# North Dakota Department of Transportation

## ADDENDUM 1 – JOB 32

TO: All prospective bidders on project HRR-8-200(020)951, Job No. 32 scheduled for the April 10, 2015 bid opening.

Revised	3/31/15	STATE	PROJECT NO.	SECTION NO.	SHEET NO.
		ND	HRR-8-200(020)951	130	4

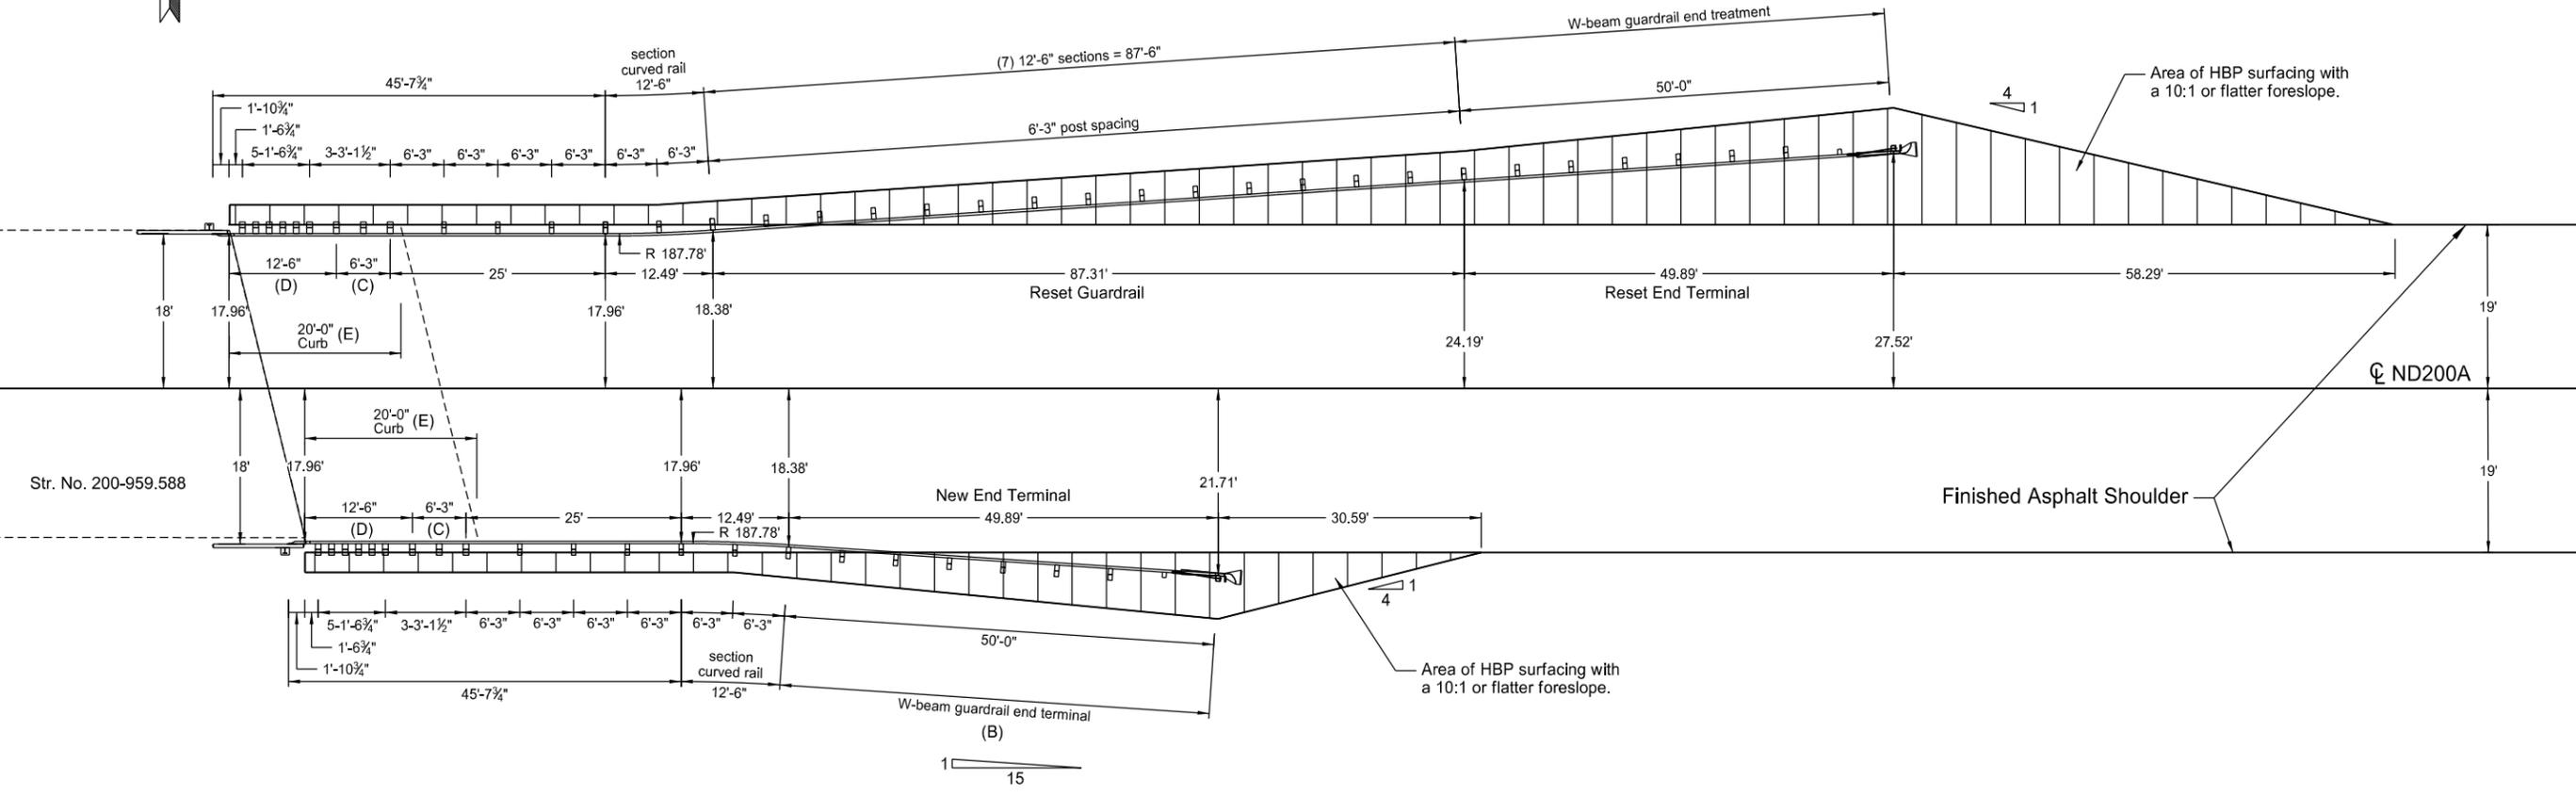
Revised Guardrail Notes.

Added labels for the guardrail and end terminals to be reset and dimension for the curved rail.

Offset dimensions were revised by 0.04' to reflect connection plate.

Sheet Added	3/24/15	STATE	PROJECT NUMBER	SECTION NO.	SHEET NO.
		ND	HRR-8-200(020)951	170	16A

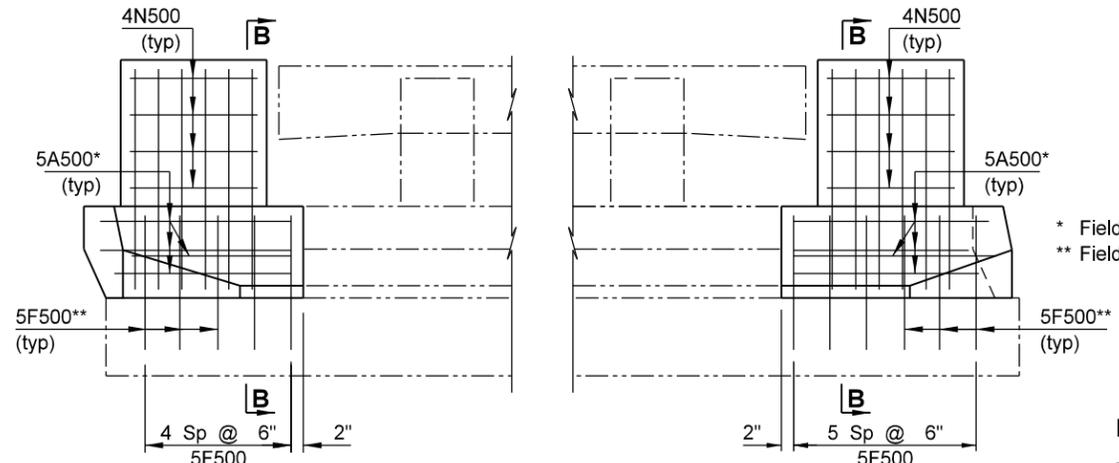
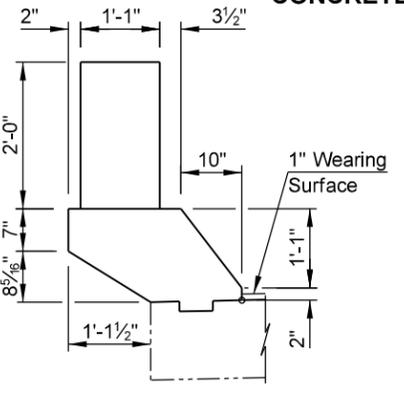
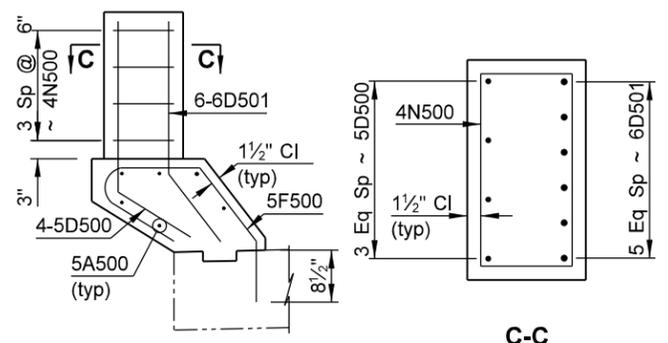
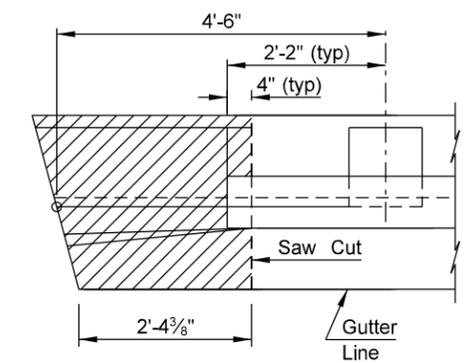
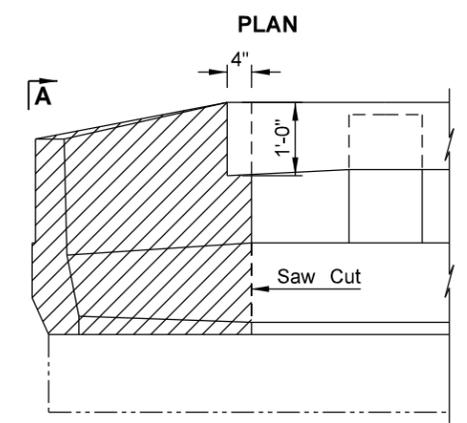
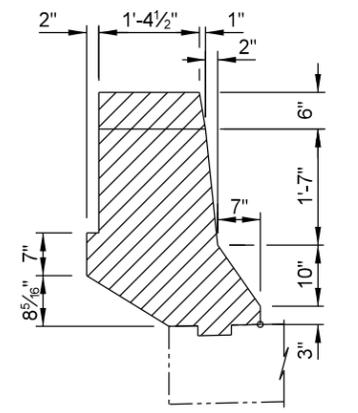
End Post Modification Details Sheet added.

Revised	3/24/15	STATE	PROJECT NUMBER	SECTION NO.	SHEET NO.
		ND	HRR-8-200(020)951	170	17

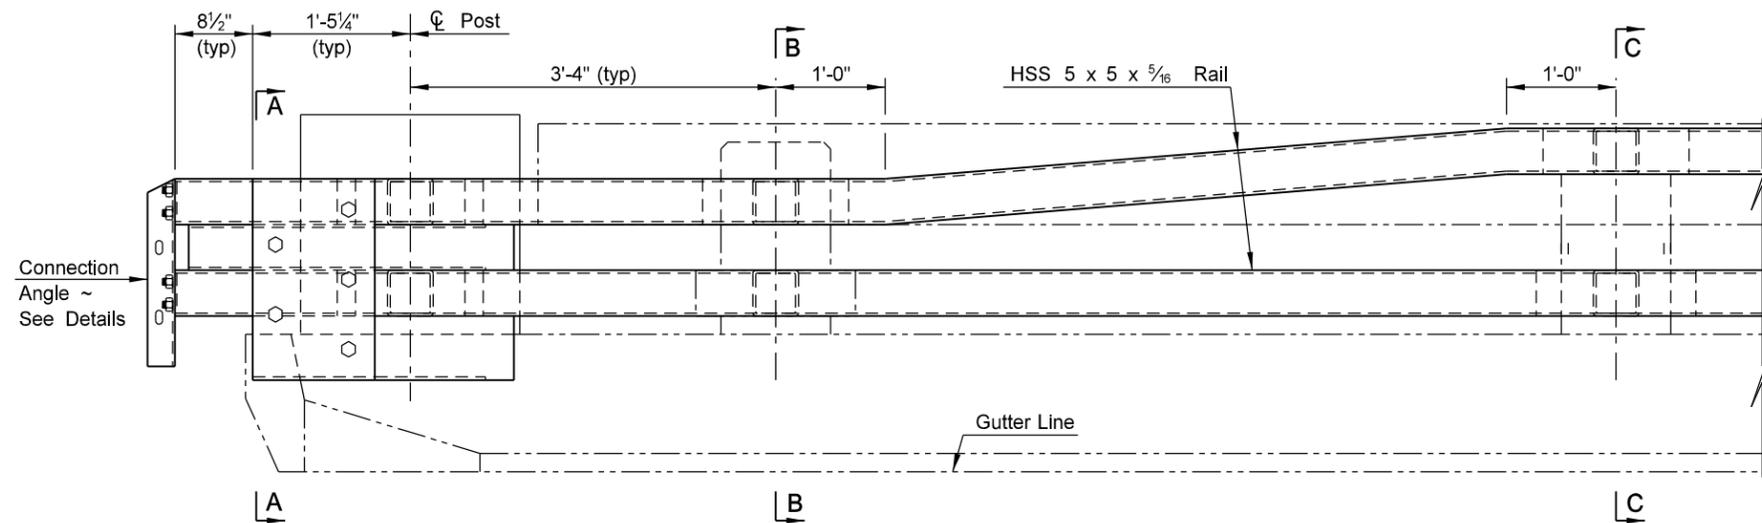
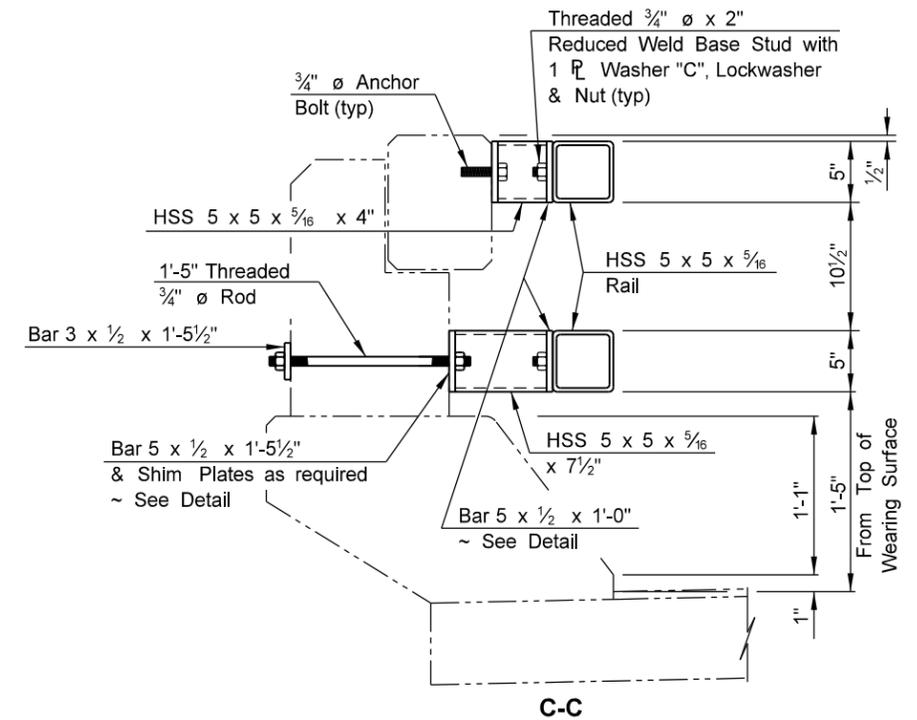
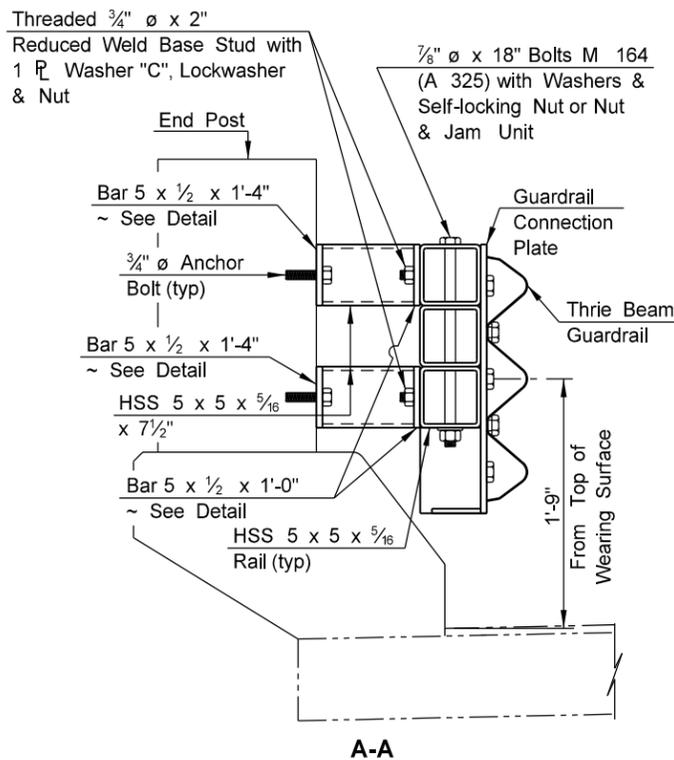
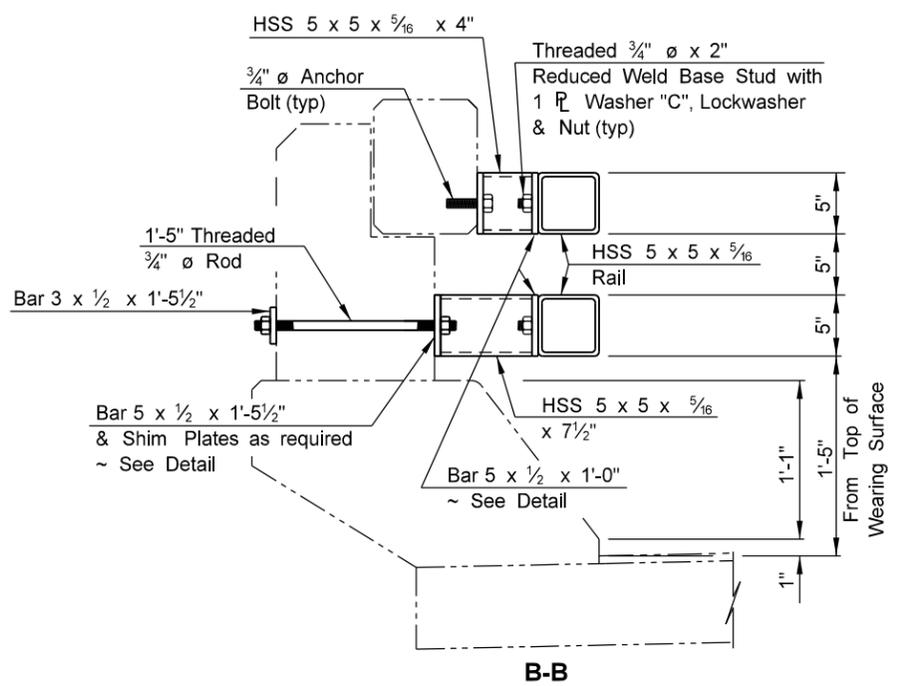
Revised End Post Detail.

Revised	3/24/15	STATE	PROJECT NUMBER	SECTION NO.	SHEET NO.
		ND	HRR-8-200(020)951	170	19

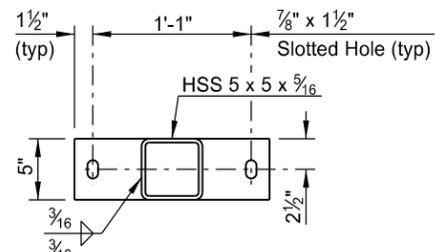
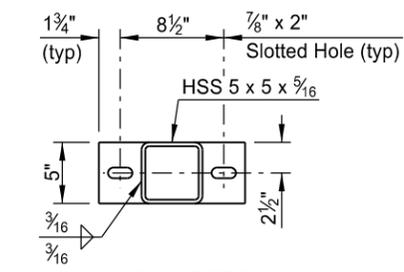
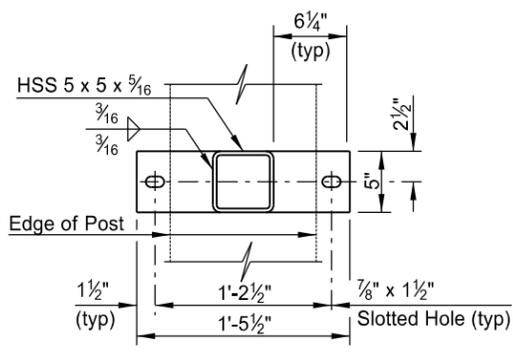
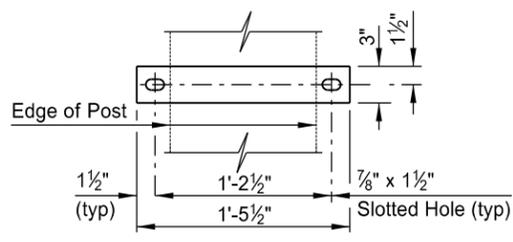
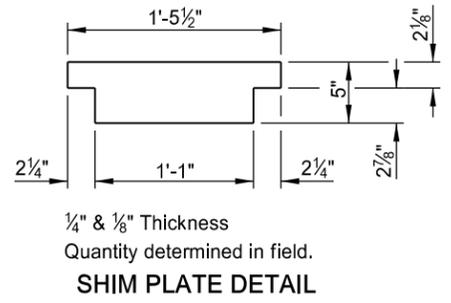
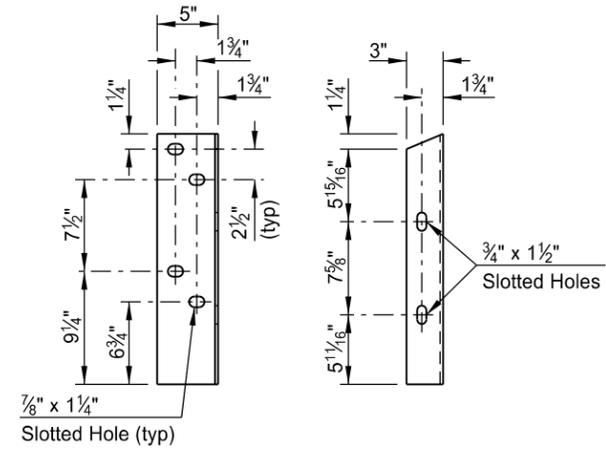
Removed Bottom rail Connection Detail.

Revised E-rail Retrofit quantity to 447.2 LF.
